**RE: Sanderway
Carrboro, North Carolina
SPEC-18092**

McAdams was tasked with reviewing the stormwater design calculations and construction drawings provided to us by Jeff Kleaveland from the Town of Carrboro on August 30th, 2018. The purpose of this review was to determine how/if the Sanderway development meets the Town of Carrboro stormwater rules and to determine what analyses were performed to ensure the downstream neighbors will not be adversely impacted by the proposed Sanderway development. The following questions/comments were generated from the review and require additional information to ensure all applicable requirements are being met for the proposed development:

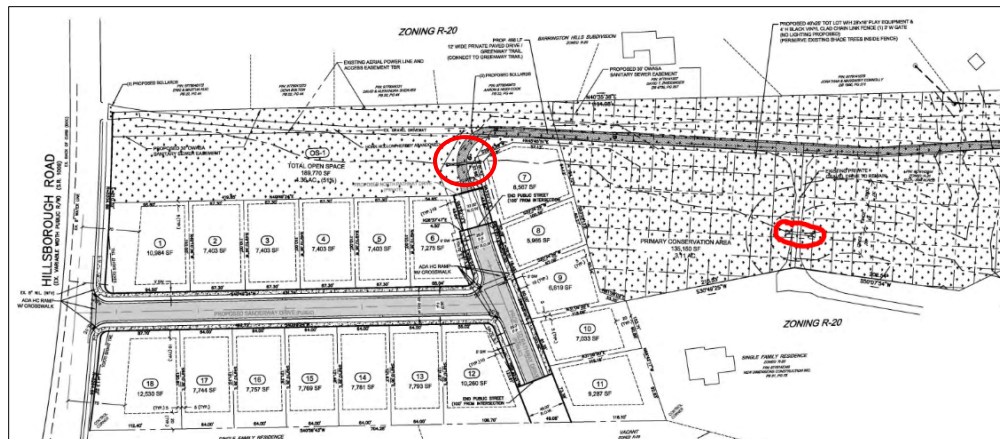
- Is there a detention exemption for the site that gets the proposed development out of 1-, 2-, 5-, 10-, and 25-year storm peak flow detention? No hydrograph analysis has been presented for review to back up the detention requirements of the ordinance.
- No information was provided to support a peak flow analysis was completed at the locations circled below and where runoff leaves the Sanderway property.

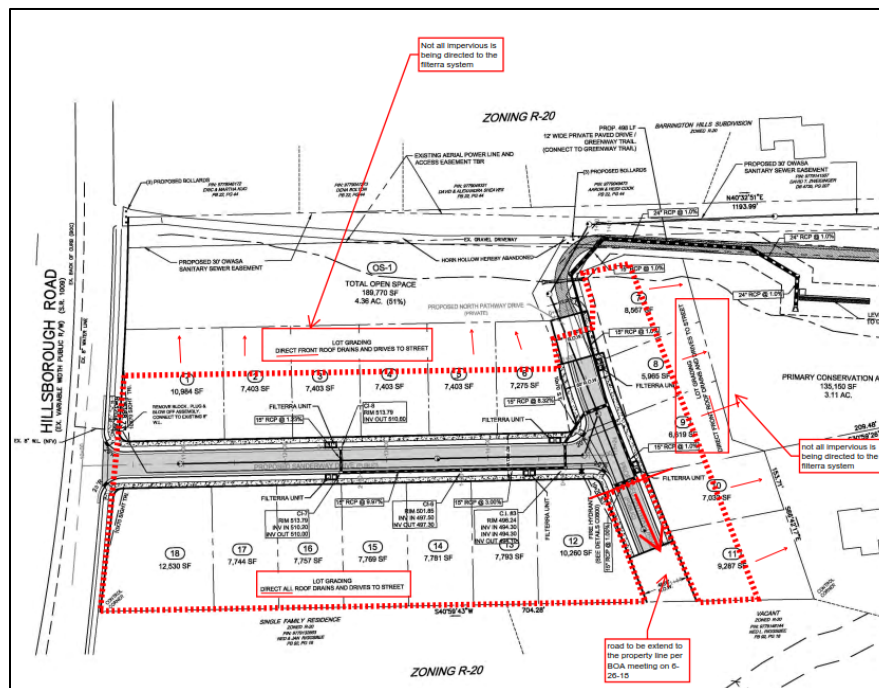
- No calculations are provided to support 85% average annual removal rate for Total Suspended Solids (TSS)
- No bypass impervious is shown in the SNAP tool, although the utility plan (sheet C0300) mentions that some areas will only take the front roof drains to the system (impervious areas on site are bypassed and do not enter the stormwater treatment system).

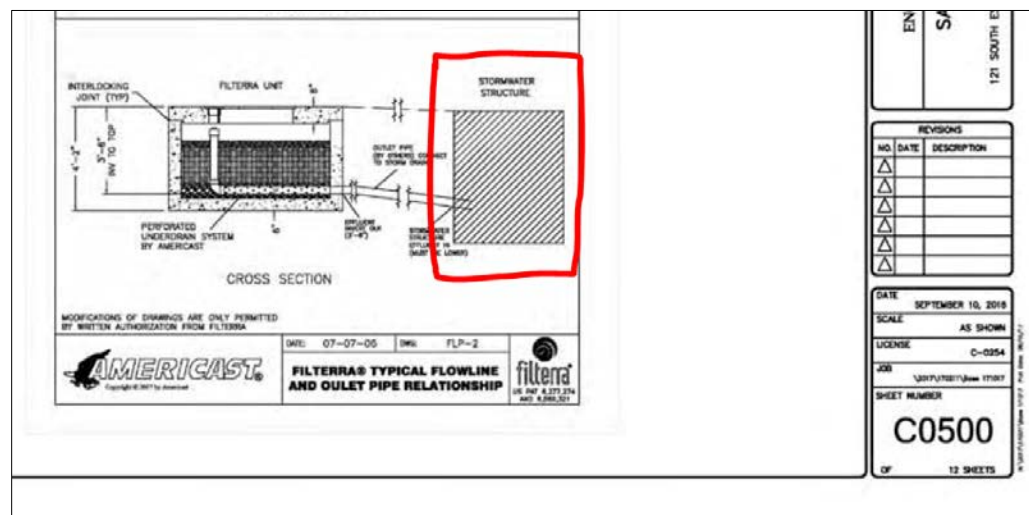
- No calculations were provided to show how detention is being provided in the “Stormwater Structure” located on sheet C0500
- What measures are taken to prevent backflow from the site drainage system to the stormwater Filterra system?

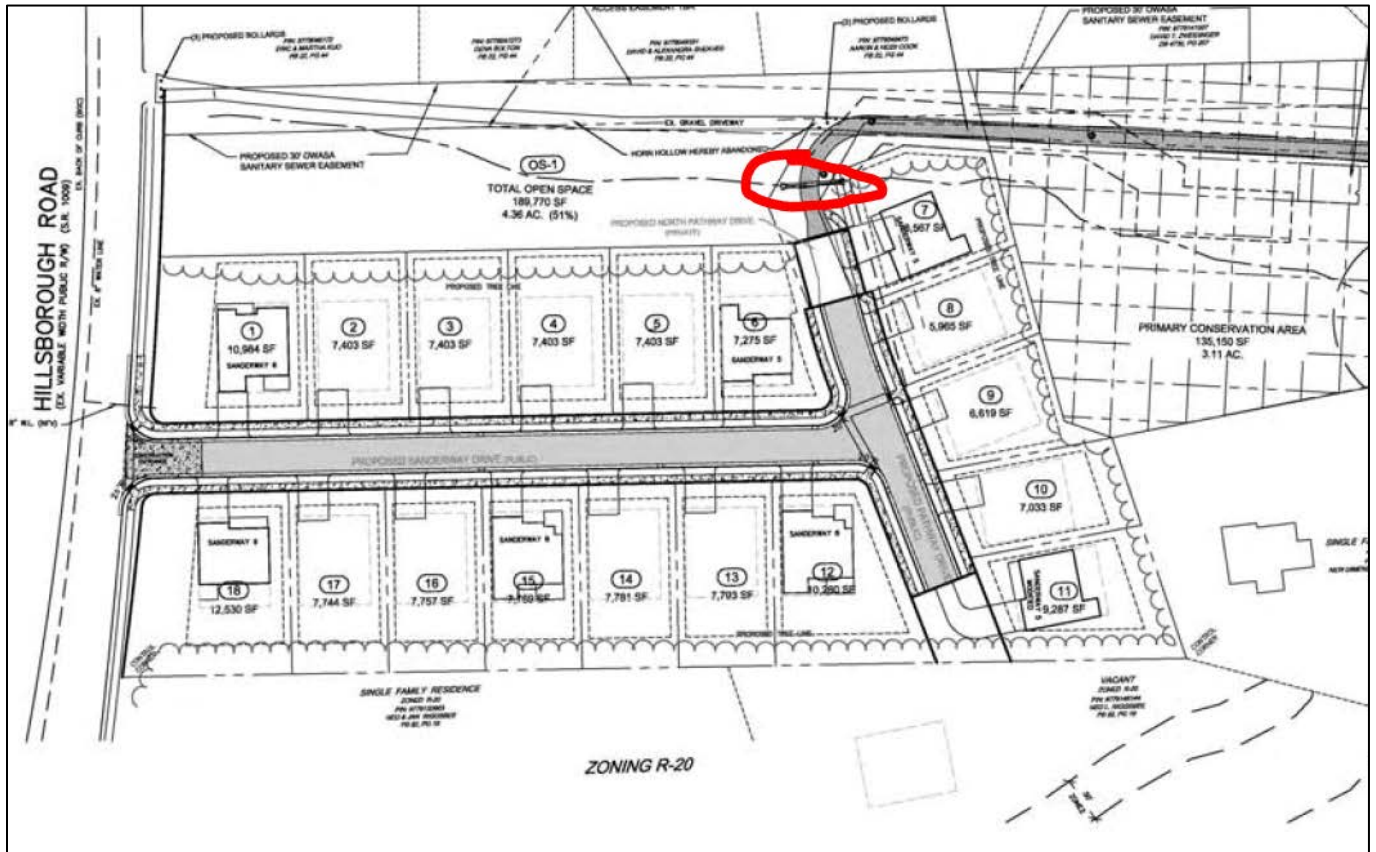
- Is the existing 12" culvert where Sanderway connects to the greenway being replaced? Not labeled on plans

- No outlet structure detail is provided for the “Stormwater Structure” that is supposed to be providing detention
- No level spreader details are provided
- No splitter box details are provided.
- No riprap is specified on the plans at the outfall.
